CERTIFICATE OF COMPLETION/OPERATION PERMIT

FILE: 4573B DATE: 7/19/02

Address of Property 15823 HUBBARD ROAD

PROPOSED PLOT PLAN

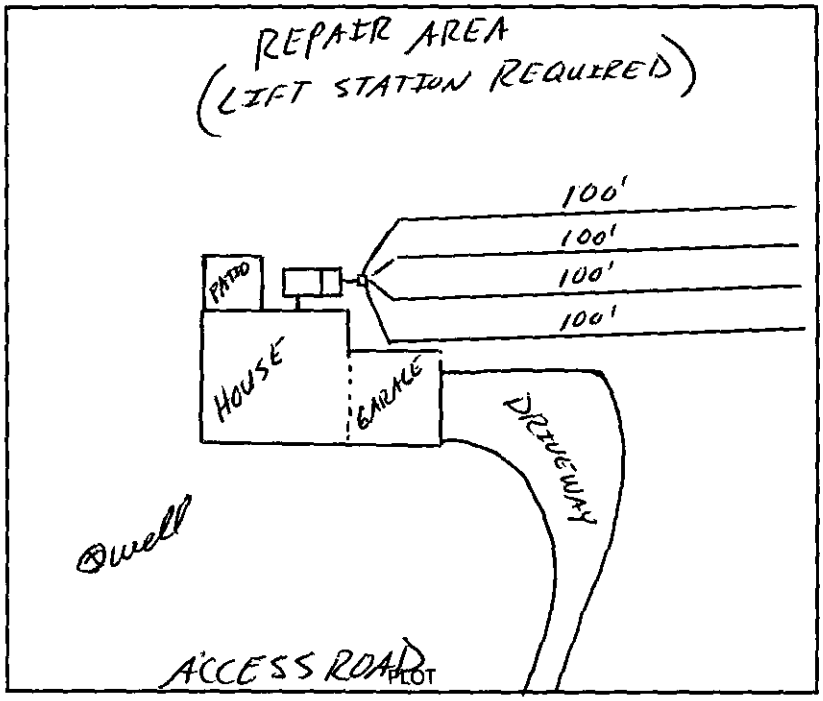
COMMENTS: Three Bedroom Residence

4 lines x 100' x 5' x 12" Stone

Type II Conventional System

* Repair system will require a lift station

PLOT OF SYSTEM

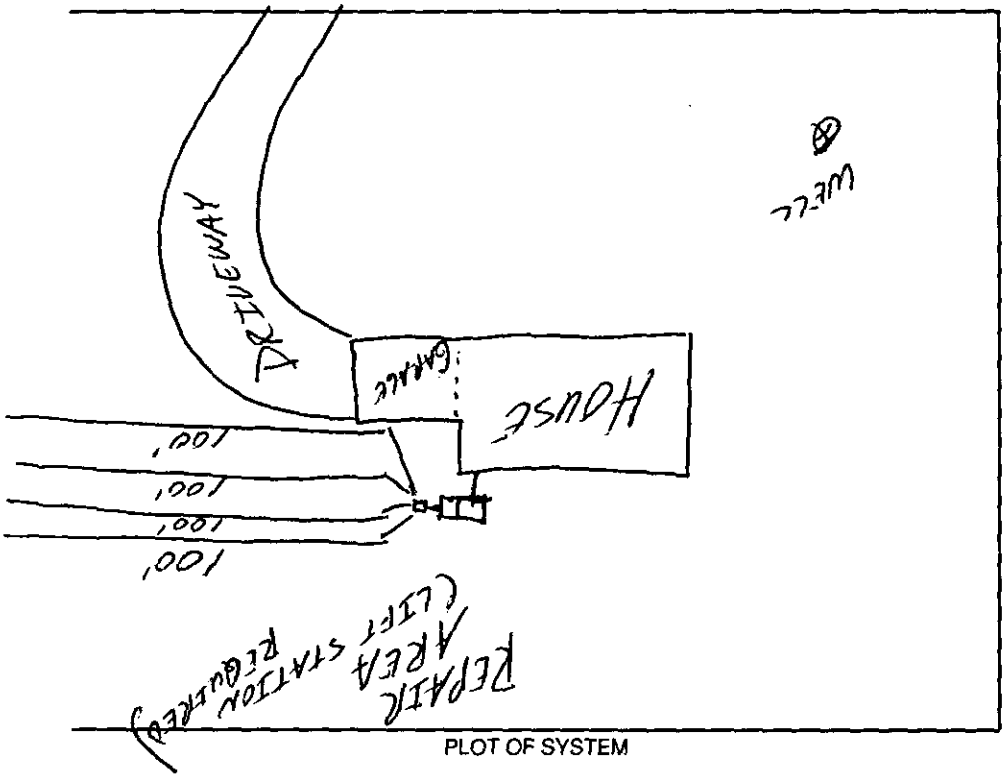
Comments: Three Bedroom Residence
Install 4 lines x 100' x 3' x 12" Stone
Type II Conventional System
Repair Area will need lift station.

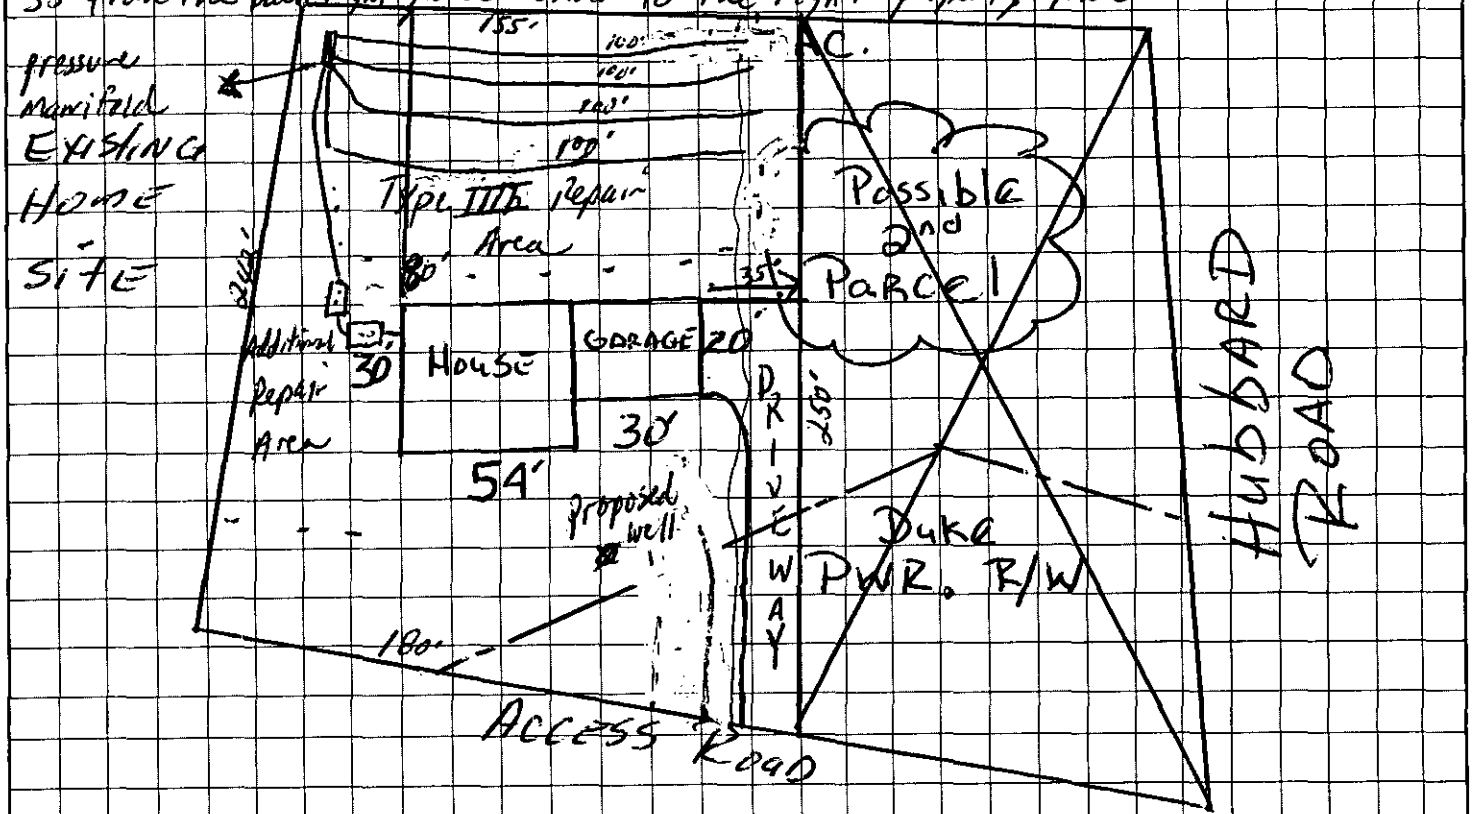
COMMENTS 3 bedroom residence, Lift pump required, 1500 ST, 1000 DT, Pressure manifold distribution, 4 lines x 100' long x 3 and x 12" stone 400 LF type IIIb Repair Area, Keep the septic system + 100' (50' min) from any wells 80' from the back left house corner to the back property line 35' from the back right house corner to the right property line

PROPOSED PLOT PLAN

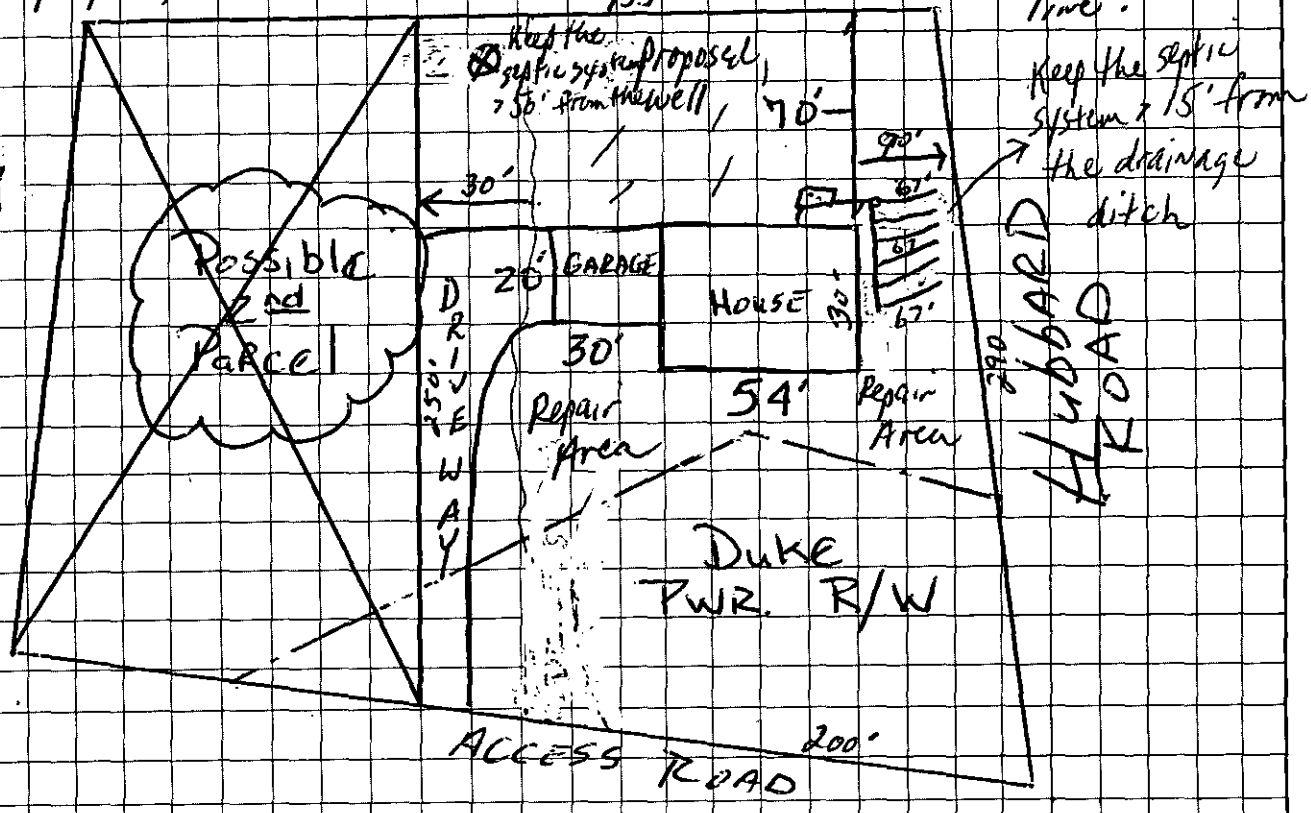
COMMENTS 3 Bedroom Residence, 1500 SF, 6 lines x 67' long x 3' wd x 12" stone 400 LF, Type IIa Repair Area, Keep the septic system > 50' from the proposed well. Keep the septic drainfield > 15' from the drainage ditch on Hubbard Rd. 90' from the back right house corner to the right property line. 70' from the back Right house corner to the back property line.
